**AMENDMENTS TO THE DRAWINGS**

**REMARKS**

Fig. 7

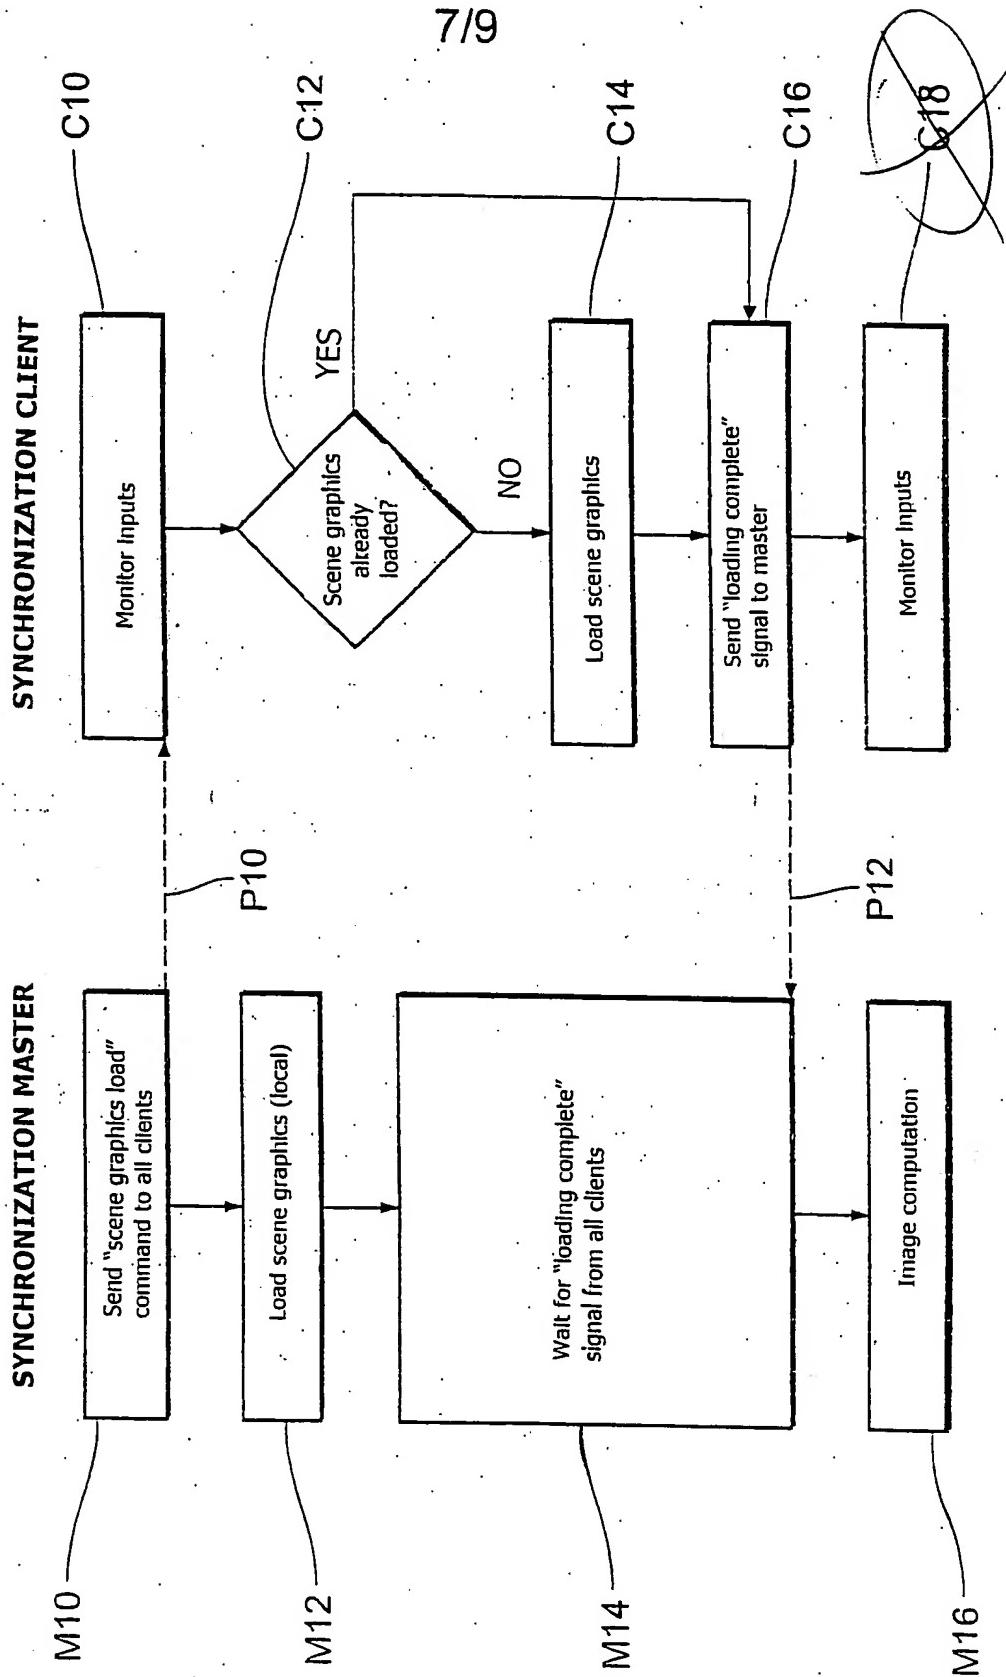
The attached two sheets of drawings include changes to Fig. 7 and Fig. 9. These sheets, which each includes only one Figure, replaces the original sheets including only Fig. 7 and Fig. 9, respectively. In Fig. 7, the reference character "C18" has been deleted. In Fig. 9, the reference characters "C34", "P20", and "P22" have been deleted.

In the current Office action, the drawings are objected to as failing to comply with 37 CFR 1.84(p)(5) because they include the reference characters not mentioned in the description.

The reference character “C18” has been removed from Fig. 7. The reference characters “C34”, “P20”, and “P22” have been removed from Fig. 9. Two replacement sheets and two annotated sheets are provided herewith. No new matter has been added. Applicants respectfully request that the amended Figures be entered and that the objection be withdrawn.
